Sag Harbor

SAG HARBOUR: 412

Suite 412 - Inventory Suite

ORIGINAL Suite
Suite 412

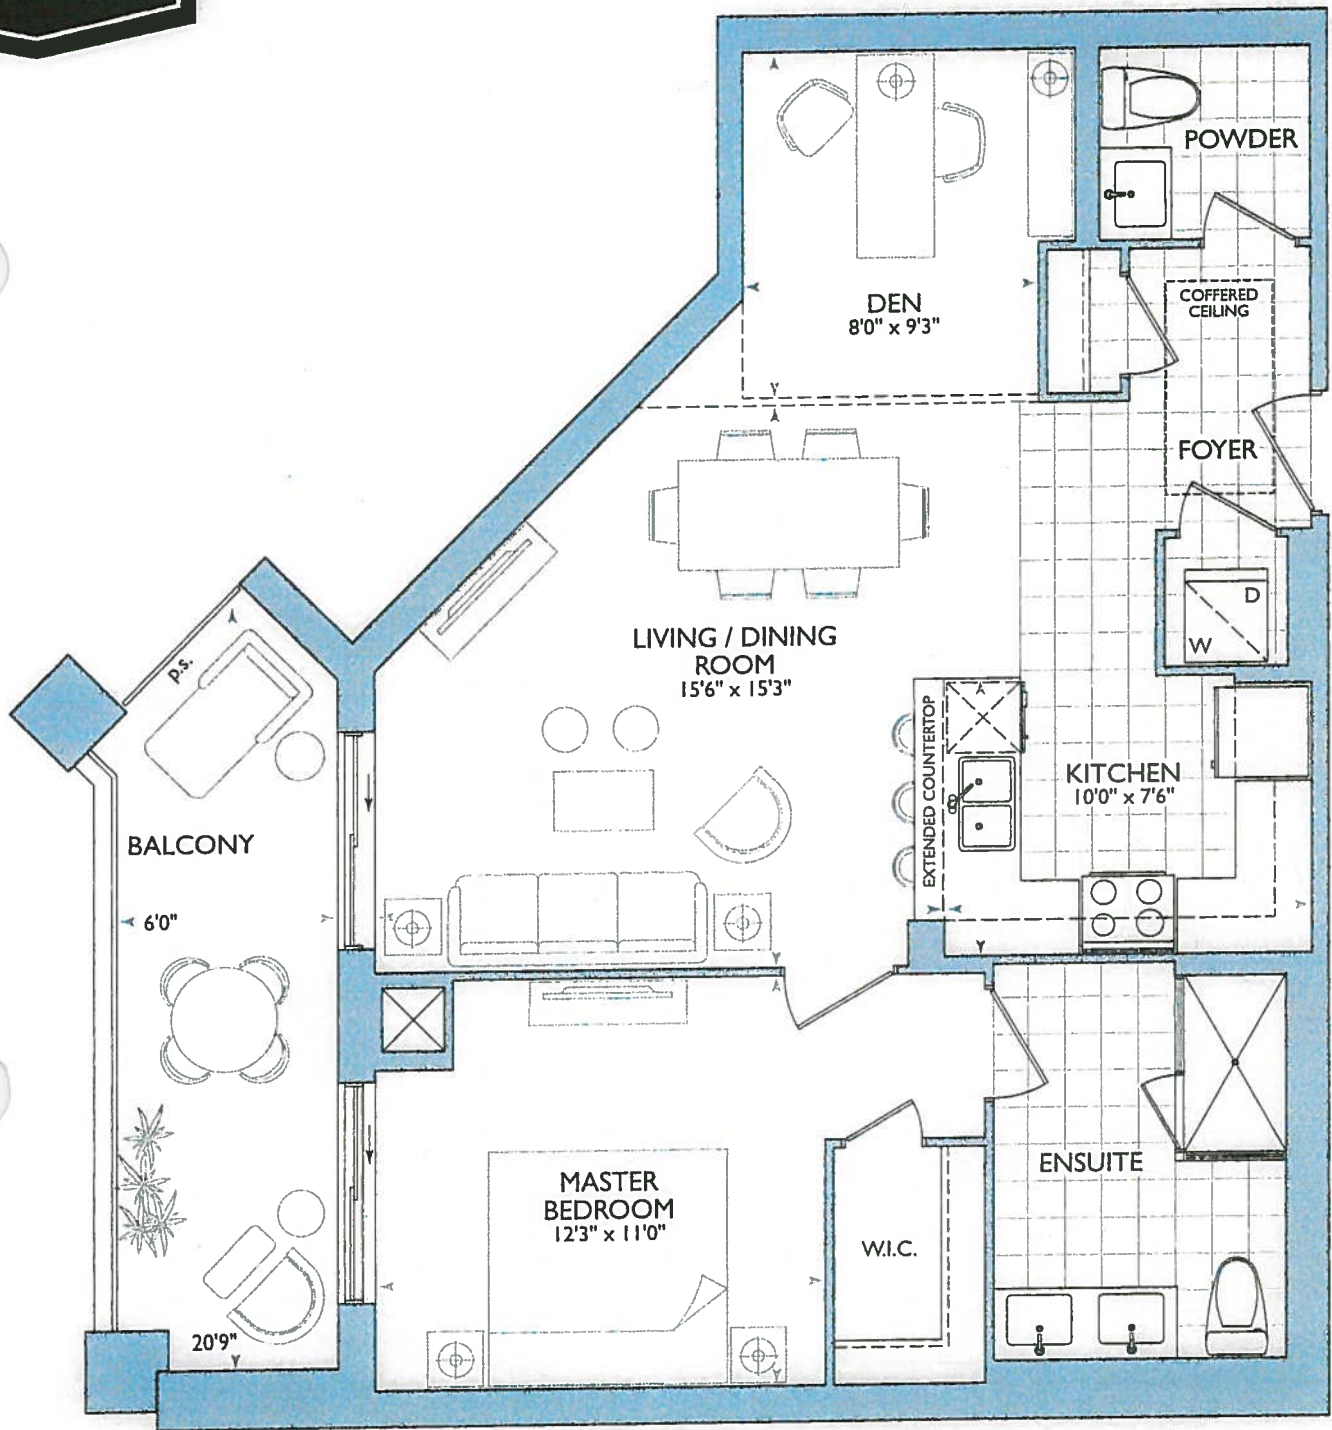
- MOVE FRONT DOOR (FOR 6" WALL BEHIND WASHER/ DRYER)

* Move Front Door - Due to 6" wall added behind w/d.

KITCHEN

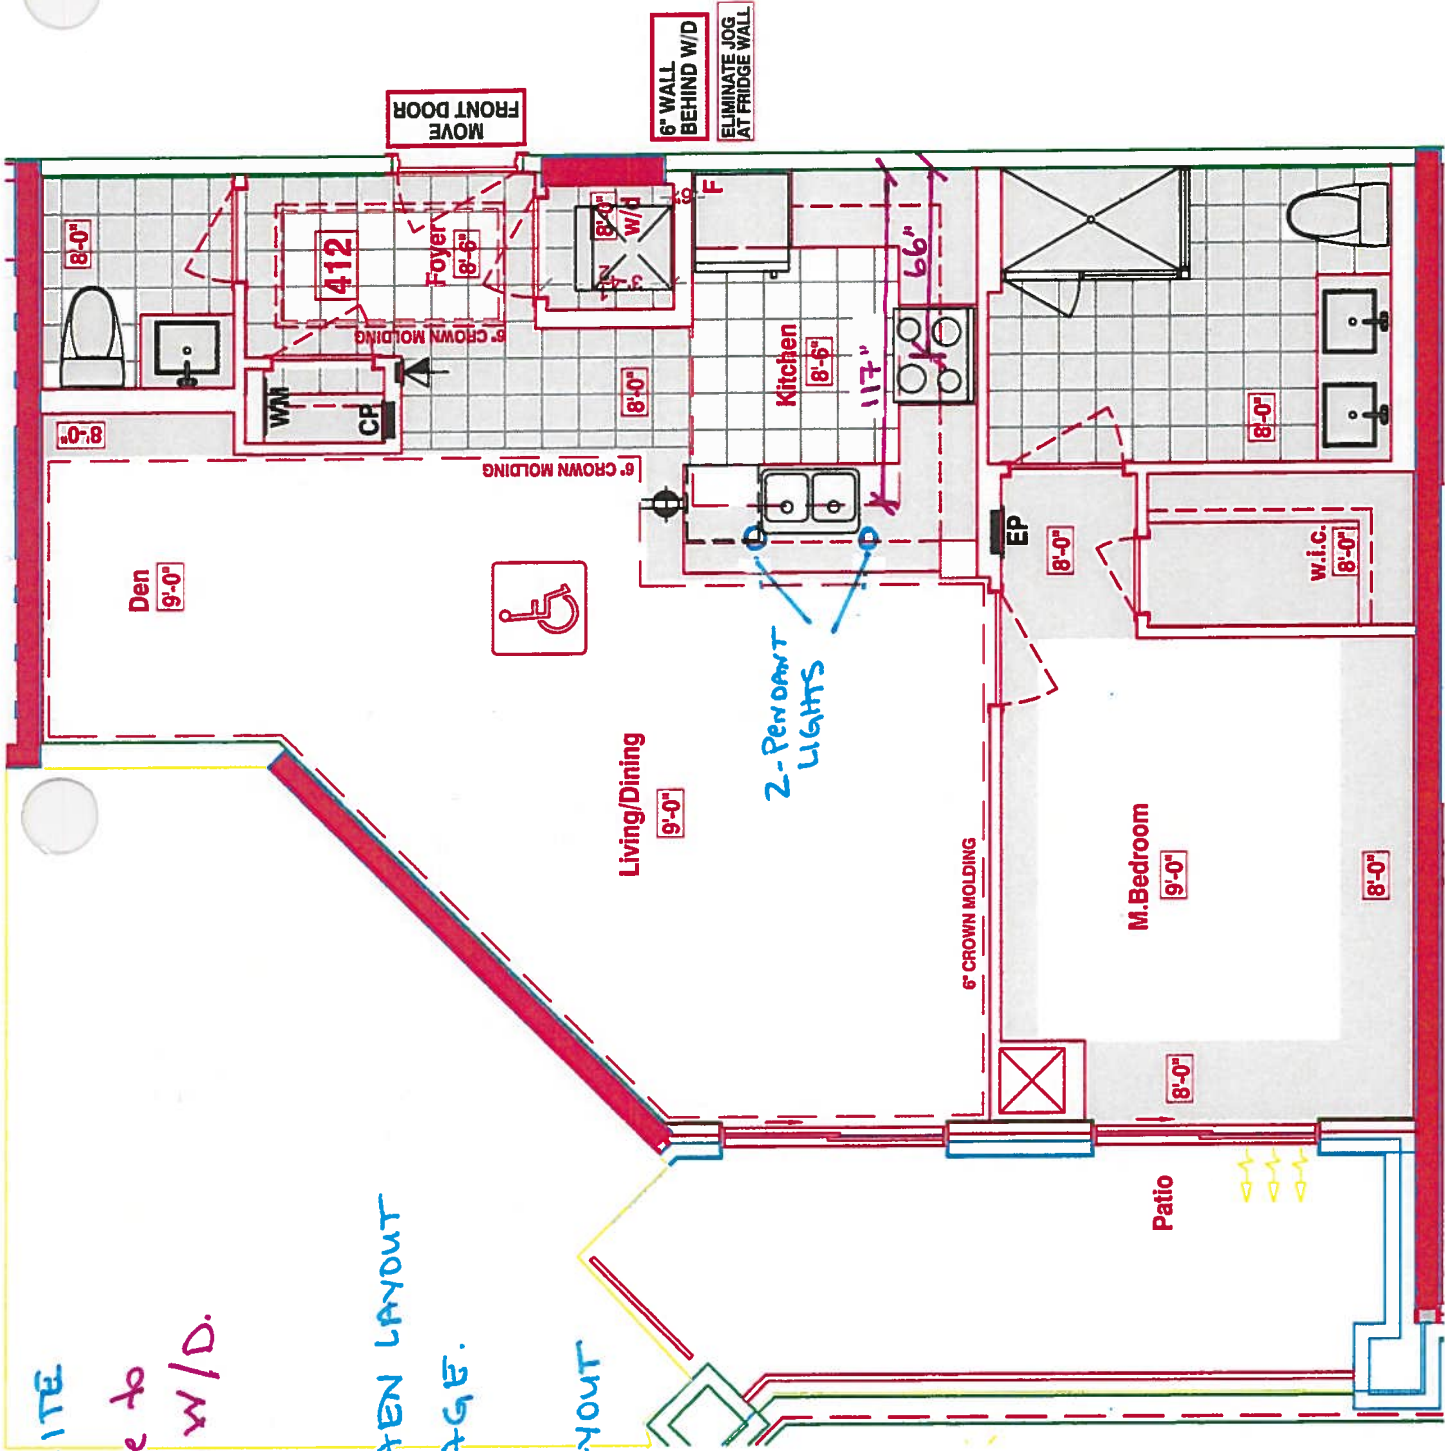
• Option of using std kitchen layout w std appliance package.

OR

• 1st upgrade kitchen layout w 1st upg appliance package

(see both kitchen layout options)

• 66" stove pipe center

• 117" sink pipe center
